Evaluation of Hydrogeochemical Issues Related to Development of the Amulsar Gold Project, Armenia: Key Assumptions and Facts

Prepared by:
Ann Maest, PhD
Buka Environmental

19 June 2017

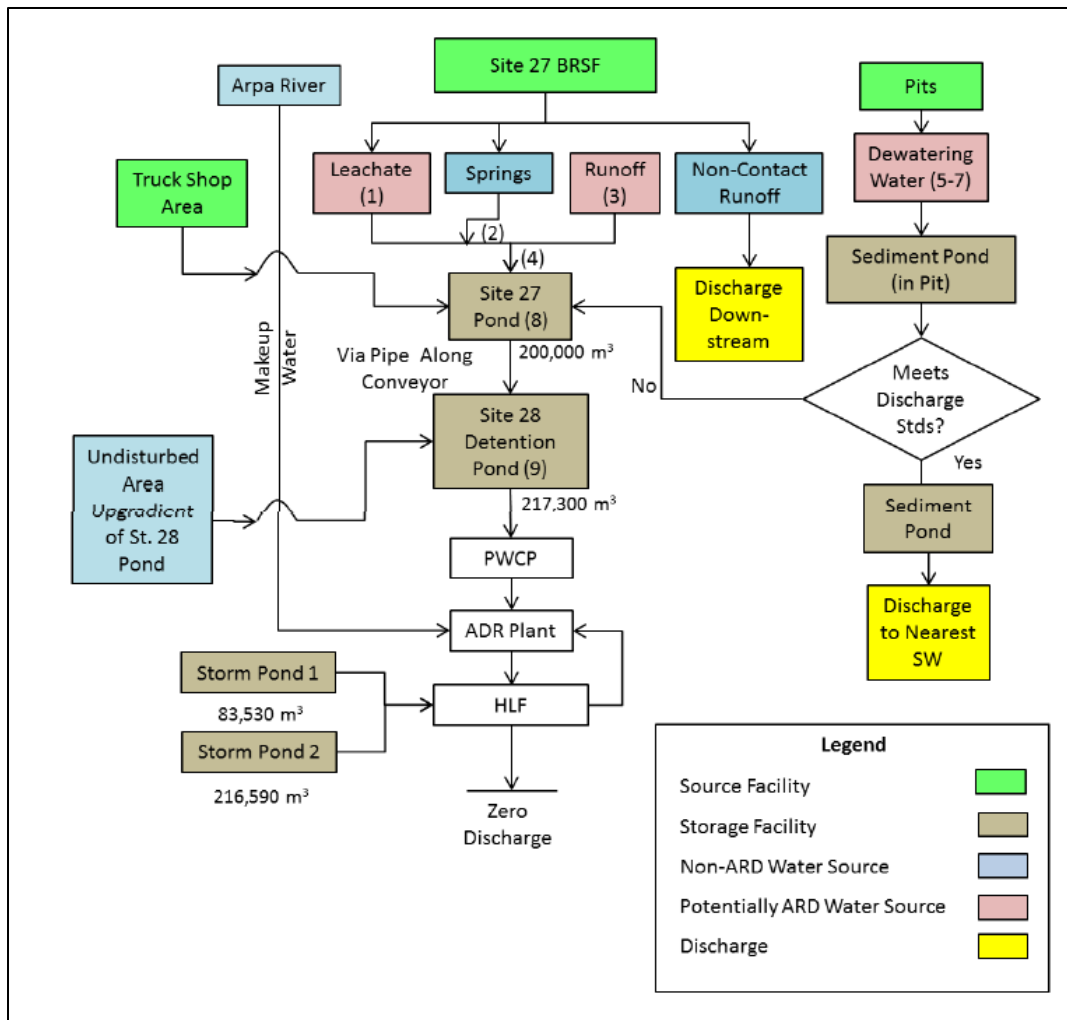
Figure 1. Acid drainage management plan schematic during operations. Note that no treatment is proposed during operations for acidic drainage generated by the mine. During mining, acidic drainage will be generated by the barren rock storage facility (waste rock dump; BRSF), the pit walls, and damaged rock affected by blasting of the pits. During closure/post-closure, the spent ore in the heap leach facility is also a potential source of acid drainage, but only passive treatment is proposed during closure, and no testing of water is proposed before discharging passively-treated water during closure.

Instead of active treatment, passive treatment is proposed during closure when a mine is most likely to require extra care, show impacts, and have fewer personnel on site. Lydian (2017, p. 397) notes that no studies have been performed to evaluate the performance of a passive treatment system, and bench- and pilot-scale testing must be performed during final design. Instead, this testing should be conducted as soon as possible because if the passive approach fails, which I believe it will, a completely new and significantly more expensive active treatment plant must be designed, built, and tested well in advance of mine construction. No active metal mine in the United States with AMD that I am aware of uses only passive treatment – active management and treatment are needed certainly during operation and usually during closure. Some mines with AMD – such as the Golden Sunlight Mine in Montana, USA, and the Tyrone and Chino Mines in New Mexico, USA – are required by state governments to provide perpetual water collection and active treatment. The Amulsar Project needs an active treatment plant during mining and likely during closure, and given the mix of constituents, including metals, metalloids, sulfate, mercury, and nitrate/ammonia, a reverse osmosis plant should be required.

- An active treatment plant should be designed and tested for use during operations and likely during closure. Given the mix of constituents, including metals, metalloids, sulfate, mercury, and nitrate/ammonia, a reverse osmosis plant should be required.

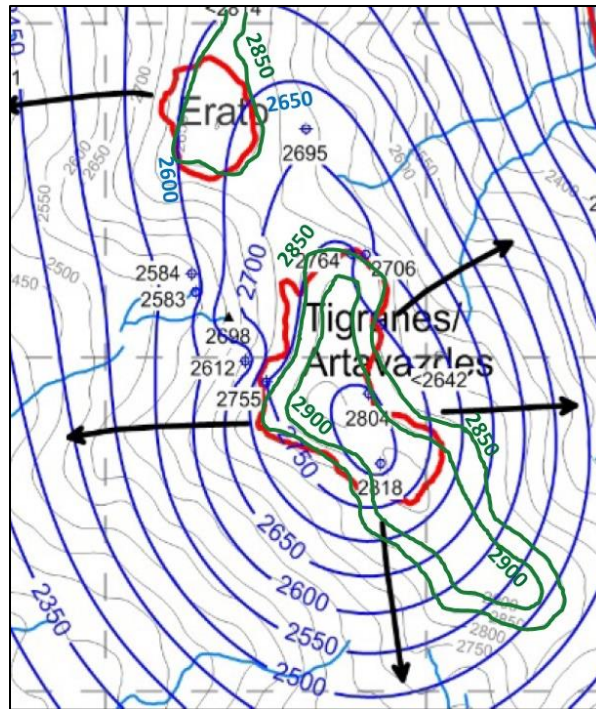
According to the results of groundwater modeling, no groundwater will flow into the pits during mining (ESIA, 2015, p. 3.67). However, a comparison of ground surface elevation on the sides of the pits vs. measured depth to groundwater shows that bedrock groundwater could easily flow into the pits during mining (Figure 2). As noted in the ESIA (p. 4.8.36), groundwater discharge occurs even at high elevations on Amulsar Mountain, and the water table is close to the surface near the ore bodies, which is where the pits would be located. Groundwater elevation varies seasonally, with up to 48 m of variability in unaltered LV rocks and in the HLF area (ESIA, Table 4.8.7). Hydraulic conductivity is also described as “highly variable,” and numerous faults have been identified near the ore bodies (ESIA, Appendix 4.8.7, Drawing 4.8.4).

Figure 2. Average Groundwater elevations (in blue contours) and topography (in light gray contours, highlighted in dark green near the pits). The edges of the Tigranes/Artavazdes pit are close to 2850 m elevation. The maximum pit depth is expected to be 270 m, which would put the bottom of the pit at 2600 m ($2850 - 270 = 2580$ m). Two wells inside the pit had higher average groundwater elevations of 2804 and 2818 m, which indicates that groundwater could easily flow into the pit. The edges of the Erato pit are also at approximately 2850 m elevation. The anticipated maximum pit depth is 225 m, which would put the bottom of the pit at 2625 m ($2850 - 225 = 2625$ m). No wells are located in the pit, but a well just outside the pit had a higher average groundwater elevation of 2695 m, and the 2650 m average groundwater elevation contour, which is 25 m above the pit boundary, crosses the pit outline, indicating that groundwater could also flow into the Erato pit during mining. The figure shows average groundwater elevation, and levels would be substantially higher seasonally.

springtime, when water levels in many wells are much higher, and the movement of groundwater along faults. As noted in Lydian (2017; p. 397), “Site runoff, evaporation, seep and spring flow, surface water flow, and pit dewatering models all require additional model verification against field data.” Special attention is needed on pit dewatering, which is currently and erroneously assumed to only include pumping of pit runoff and direct precipitation. Additional seasonal data and additional wells or piezometers are needed around the planned outline of the pits to evaluate the likelihood of bedrock groundwater inflow to the pit during mining. Such a water balance study will cost in excess of the \$100,000 proposed in Lydian (2017, p. 397).

- Additional seasonal data and additional wells or piezometers are needed around the planned outline of the pits to evaluate the potential for bedrock groundwater to flow into the pits during mining. In the likely event that groundwater will need to be pumped to keep the pits dry, a full-scale reverse-osmosis treatment plant will need to be constructed before mining begins. Neither the ESIA nor any other mine document contains a contingency plan for construction or use of a treatment plant during mining.

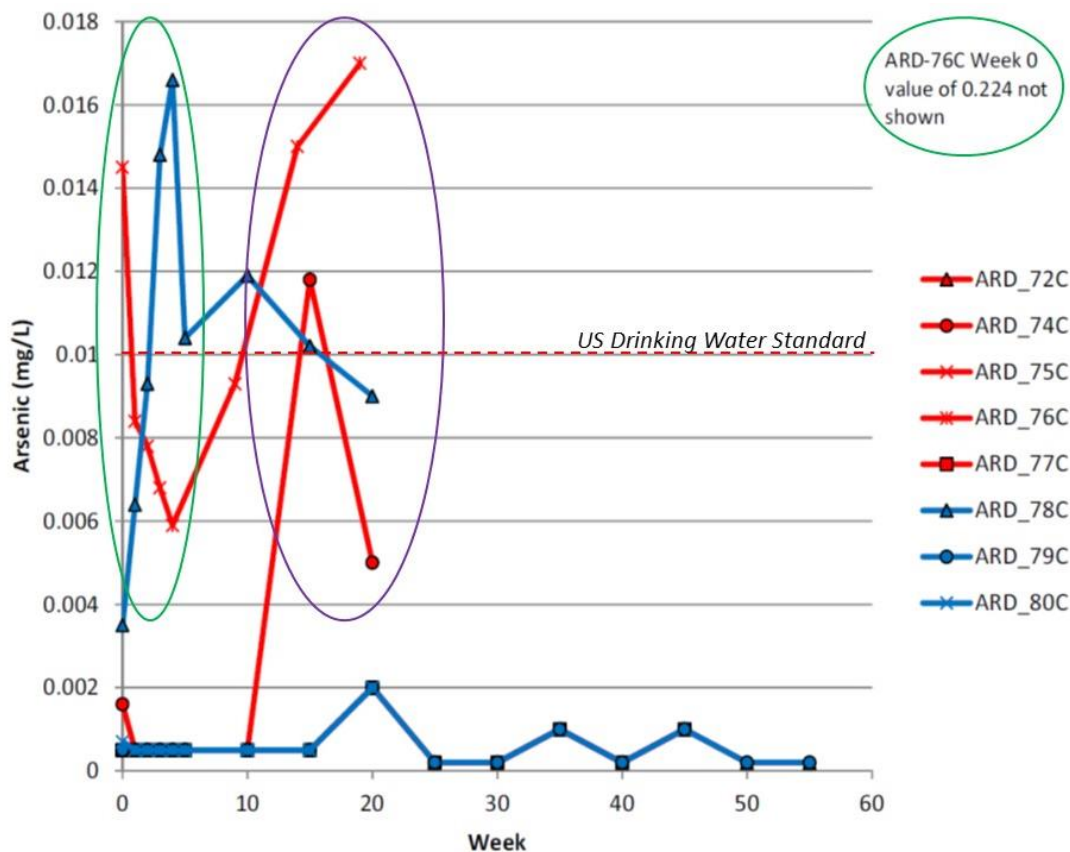
Figure 3. Humidity cell test leachate results for arsenic for barren rock from the A/T pit. Results in red are from the Lower Volcanics, and results in blue are from the Upper Volcanics. Results circled in green are “early flush” concentrations and show that weathered rocks can leach elevated concentrations of arsenic (and other contaminants) quickly. Results circled in purple show that the test was ended too early for two of the LV samples, and maximum concentrations of arsenic may not be known. See text for more detail.

The HCTs were conducted on a small subset of the types of rock and alteration types at the site. Kinetic testing such as HCTs provide the best indication of long-term leaching of the geochemical testing conducted for the Amulsar Project. Only eight HCTs were run: five from LV and three from UV rocks. Additional HCTs should be run for at least one year, or until concentrations peak and stabilize, even if the samples produce acid rapidly. The results from the additional HCTs can be used to evaluate the “ferric iron resistance” of LV rocks proposed in the ESIA and related documents. Table 3 shows that the HCT samples were not representative of the larger UV and LV rocks in terms of mercury, antimony, arsenic, and copper content. Mercury, antimony, arsenic, and copper concentrations in the samples selected for long-term kinetic testing were not representative of the mid and higher range of values in the larger set of UV and LV rocks. Results from the HCTs, which are used to predict contaminant concentrations during and after operations, will therefore likely underestimate leaching of mine wastes.

Figure 3 shows that initial concentrations of arsenic were high in samples from both UV and LV rocks; the week zero result for LV sample ARD-76C was 0.224 mg/L arsenic, which is over 20 times higher than the US, European Union, Australian, Canadian, and South African drinking water standards.¹⁹ The UV sample with high arsenic concentrations, ARD-78C, had very low pyritic sulfur content (0.06 %; ESIA, Appendix 4.6.2, Appendix Table A-1) but high total arsenic concentrations (601 mg/kg; ESIA, Appendix 4.6.2, Appendix B-1). These results, and those for other analytes, imply that both UV and LV rocks have a high potential to leach contaminants, regardless of their sulfide content, and must be managed in a way to isolate them from water resources. The high “early flush” concentrations are an indication of the type of water quality that could be produced repeatedly - after snowmelt or a rainstorm – from weathered materials in the BRSF, the open pits, and the HFL.²⁰ In addition, Figure 3 shows that LV samples ARD-76C and ARD-74C and UV sample ARD-78C were stopped too early because arsenic concentrations had not leveled off and may not have reached maximum values. Because of the short test time, we don’t know how high concentrations could become under acidified conditions, and this is important information for the design of effective treatment methods and mitigation measures. The UV sample ARD-78C leached elevated arsenic concentrations under neutral pH conditions (pH values had not dropped below 6 during the test). When total arsenic concentrations are high in UV rock samples, antimony concentrations are also elevated well above average crustal abundance values. Other metals such as copper, lead, and mercury are also elevated in UV rock samples that were not subjected to humidity-cell testing.

The elevated concentrations of leachable metals/metalloids in the UV rocks, especially arsenic and antimony, suggest that even if the pH of the UV leachate is neutral, elevated concentrations of contaminant will likely be released. In turn, the “encapsulation” of PAG LV rock in “a protective rind of non-acid-generating UV waste” (ESIA, Appendix 8.19, ARDMP, p. 4) does not increase confidence that the proposed acid drainage management plan will be successful. Based on the limited long-term leach testing conducted, the use of UV rock as construction material is similarly not advised because of its strong potential to leach arsenic, antimony, and other contaminants. Additional testing is needed.

- Additional geochemical testing should be conducted, including more acid-base accounting, mineralogy, and humidity-cell testing on samples from all proposed pits, waste rock, and ore. Additional geochemical testing units should be identified based on mineralogy and alteration

and used for all testing. The additional HCTs should be run for at least one year, or until concentrations peak and stabilize, even if the samples produce acid rapidly. The results from the additional HCTs can be used to evaluate the “ferric iron resistance” of LV rocks proposed in the ESIA and related documents and to determine if UV rocks should be used for construction materials or instead require special handling because of their contaminant leaching potential.
